PLANNING COMMISSION STAFF UPDATE MEMO

Planned Development District – 6695 S. Wasatch Blvd.

July 15, 2020

Project
PDD-19-001

FIGURE 2- CURRENT PROPOSED SITE LAYOUT – SEE ATTACHMENT 1 FOR HIGH-RESOLUTION

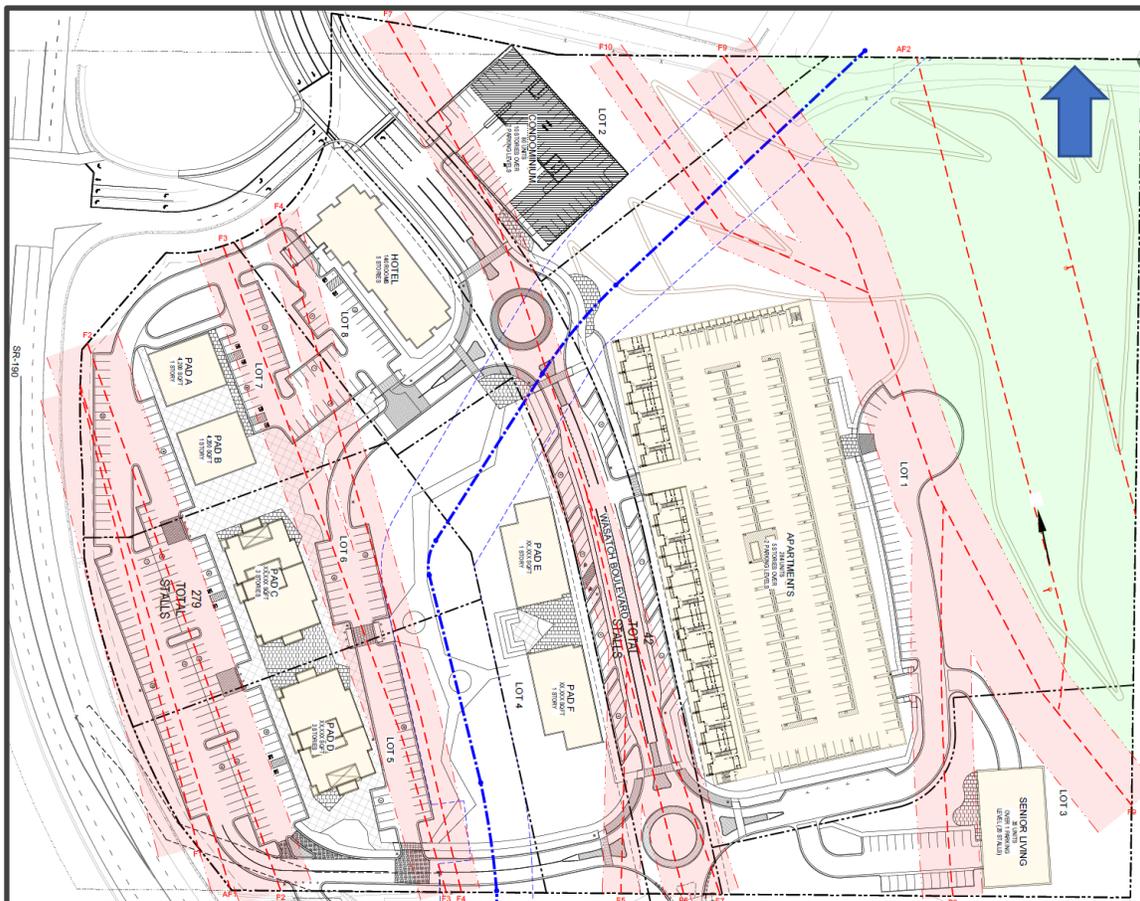
The applicant has amended the site plan twice of their own accord and have made additional changes based upon staff and Architectural Review Commission feedback. Accordingly, there is inconsistency between the current development plan and supporting documents such as the master landscape plan. All site plans need to be consistent with each other as they will be adopted as part of the regulating zoning ordinance.

Note: This report contains several graphics of the proposed development plan. Figure 2 is the current layout. Other site layouts are included which contain outdated building, driveway, and site layouts. These older plans are included to illustrate landscaping, open space, plaza, and site amenities, cycling and pedestrian circulation, and site constraints. All these plans are required to be updated with the current site layout prior to Planning Commission approval of the development plan.

FIGURE 3 - NORTH BUILDINGS - HEIGHT CROSS SECTION (RED MAXIMUM HEIGHT PERMITTED)

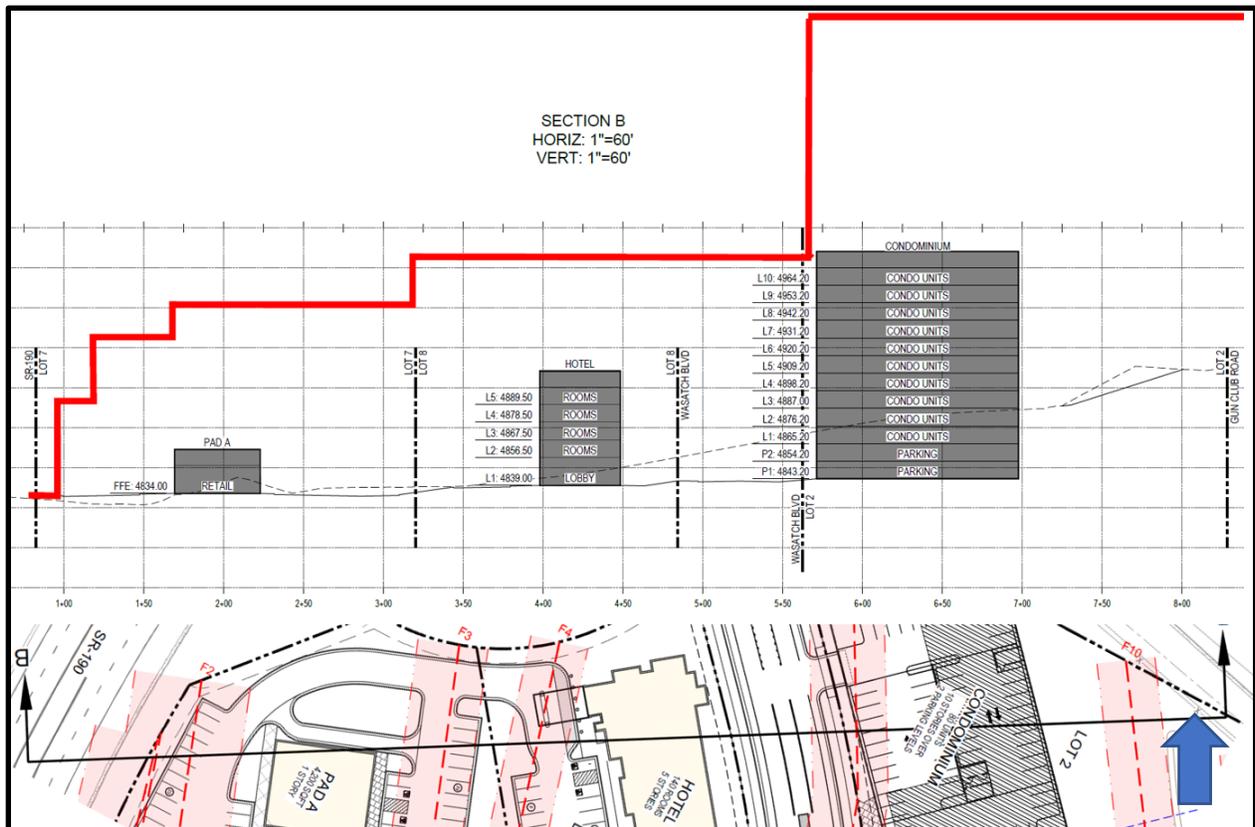
The Tier 1 PDD area allows heights much greater than what the development plan proposes (outlined in Table 1). However, when the ordinance is adopted, the heights presented in the development plan will be the maximum building height that is required for each phase of the development.

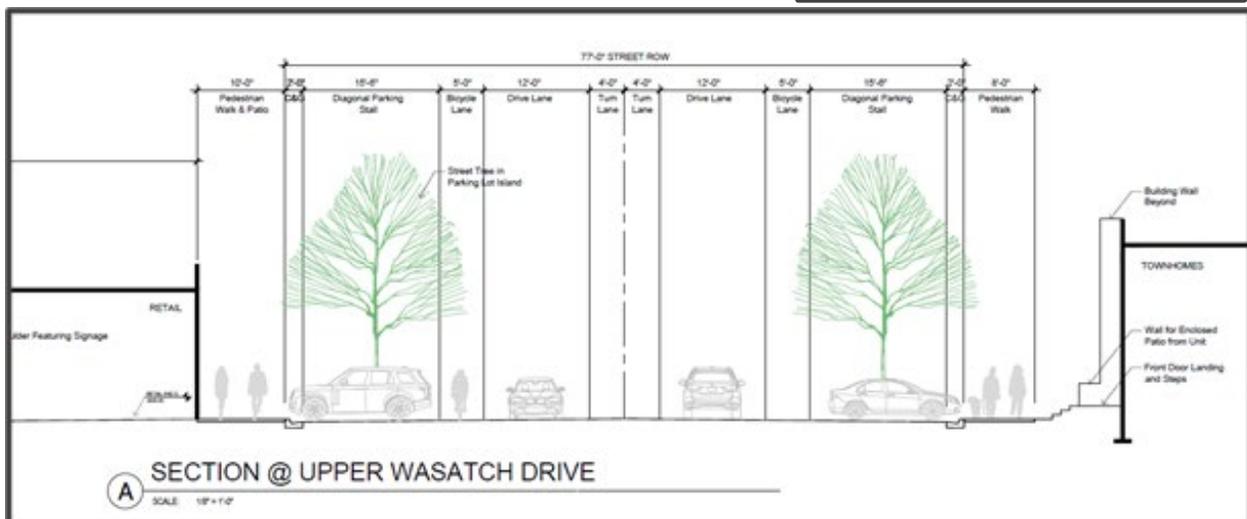
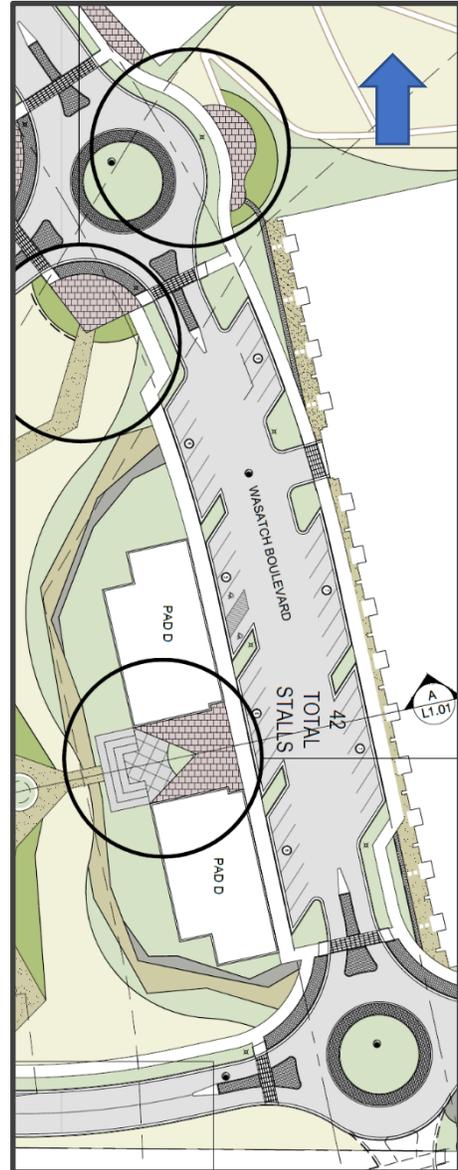
Unified Fire has reviewed the plan and has found access to each building site acceptable. Proposed roundabouts will need to be designed with an appropriate radius to allow for sufficient fire apparatus turning.

FIGURE 8 – EXISTING AND PROPOSED SITE GRADING BASED ON OLD SITE PLAN LAYOUT.

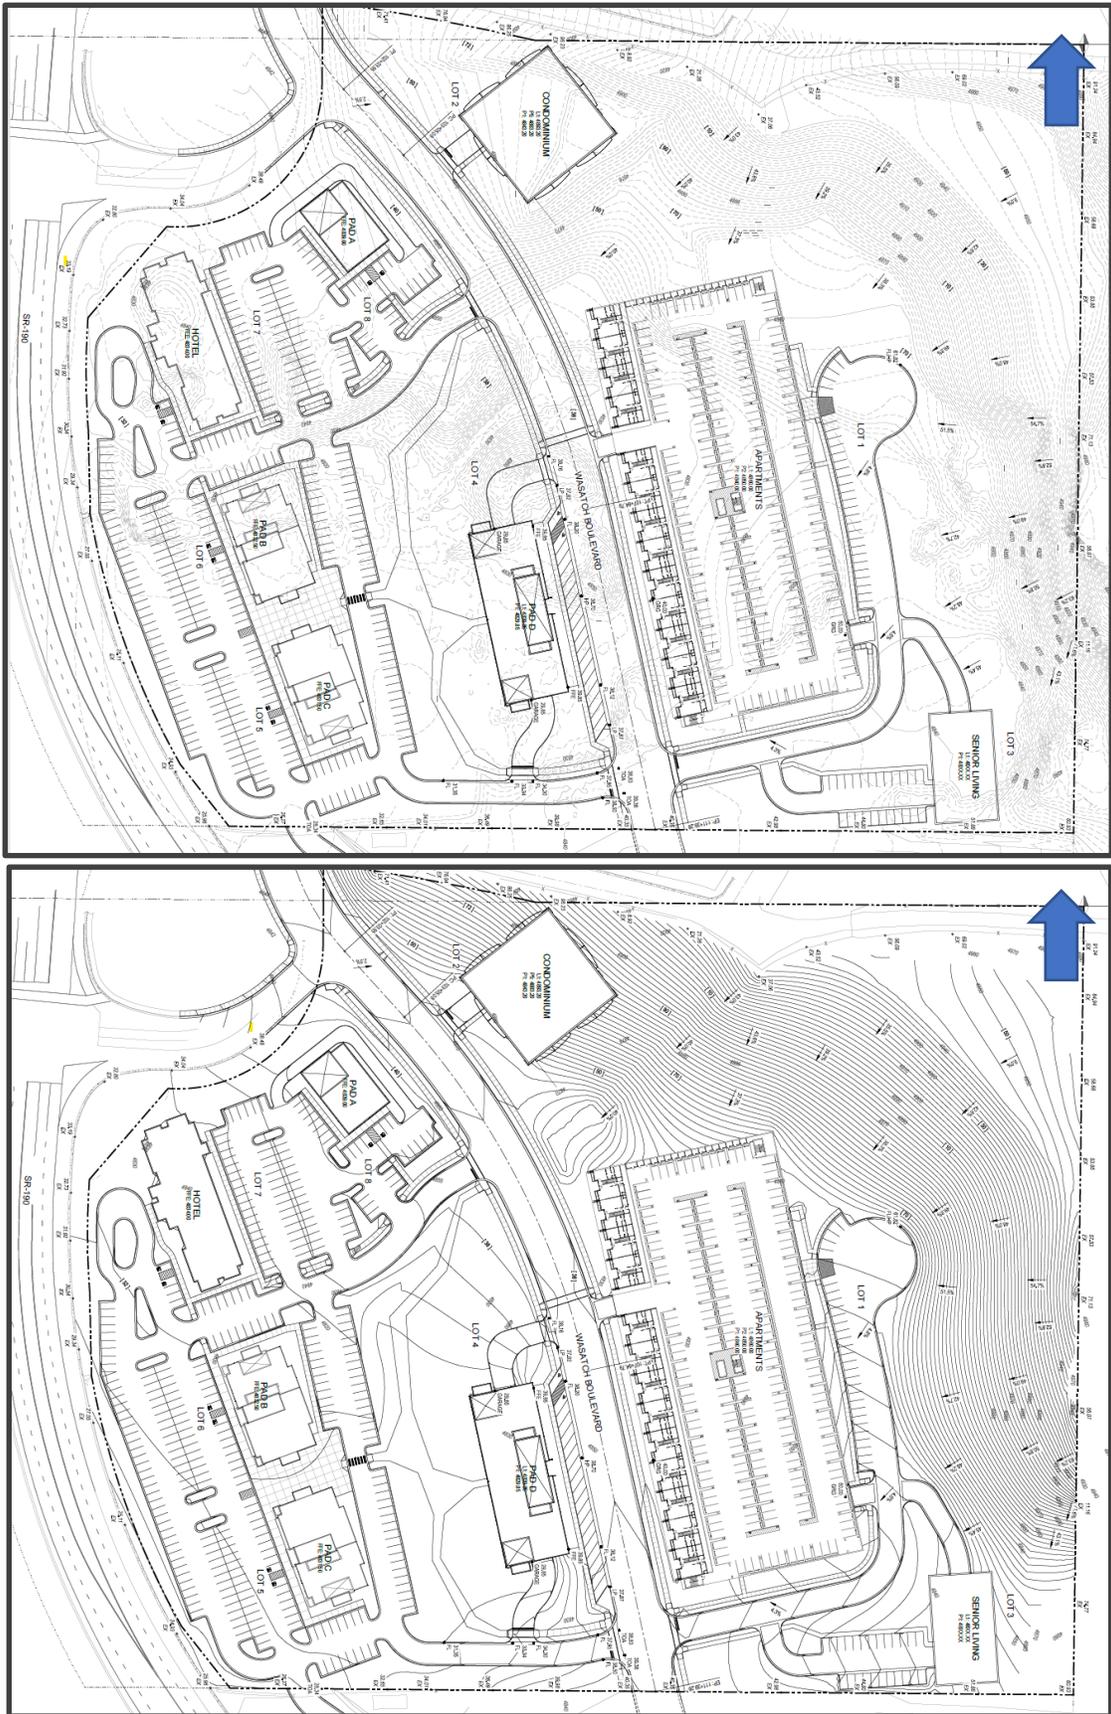
The applicant has provided additional details on the initial preliminary grading plan on the strategy to reclaim the slope as shown in Figure 9.

Public works is requesting additional planning on the reclamation prior to providing a recommendation on the development plan. The reclamation plan shall include at a minimum:

- Scope of the disturbed areas
- Drainage impact to native vegetation
- Slope stabilization methods and compaction requirements
- Erosion control methods and Revegetation Plan

Figure 9- Major Site Constraints – Red: Fault Setback Area. Orange: MDWSS Salt Lake Aqueduct

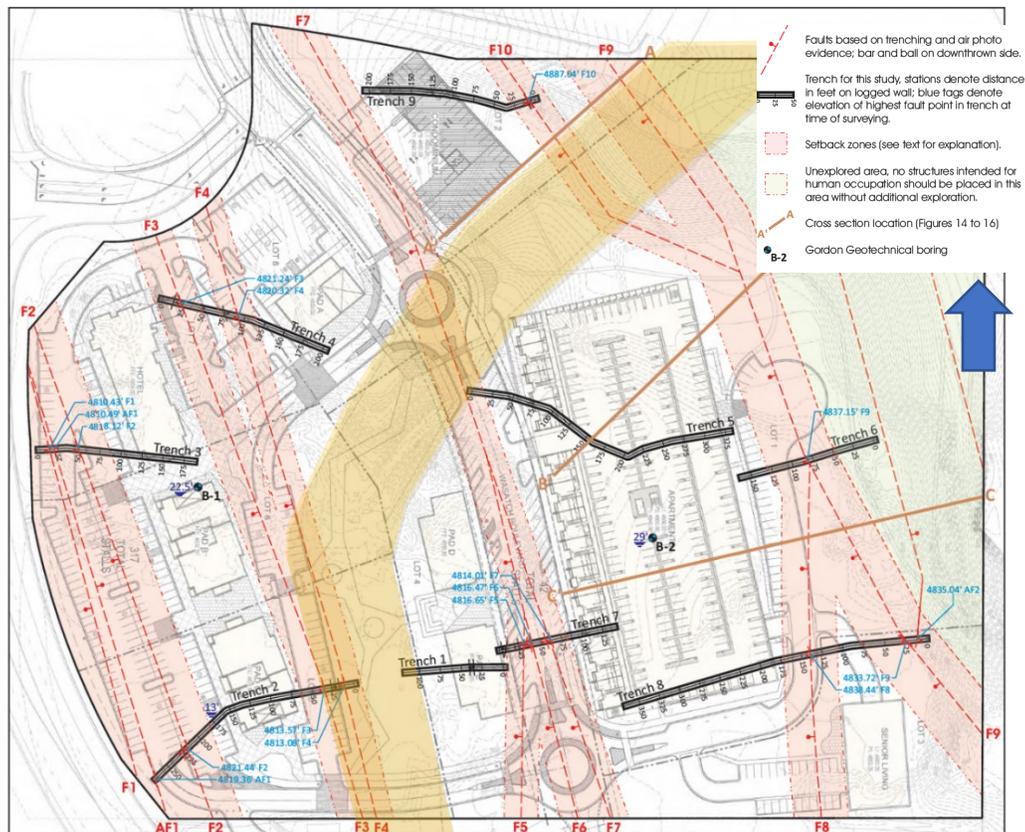
Red areas on the above diagram indicate fault lines and their required setbacks. Per the Surface Fault Rupture Study, no structures intended for human occupancy should be located in these areas. Streets, driveways, yards, parking, and other non-occupied non-attached structures may be constructed in these areas.

The **orange** area is an easement for the Metropolitan Water District of Salt Lake and Sandy (MWDSS) and created to house Salt Lake Aqueduct. No building and only limited surface development, as approved by MWDSS.

As final plan design-level geotechnical engineering studies required for each final phase may present, and as Significant cuts could change fault locations and setback zone calculations, staff recommends the inclusion of ordinance language that indicates that additionally recommendations from qualified geologic engineers and accepted by the Public Works department may negate approved locations on the Development Plan.
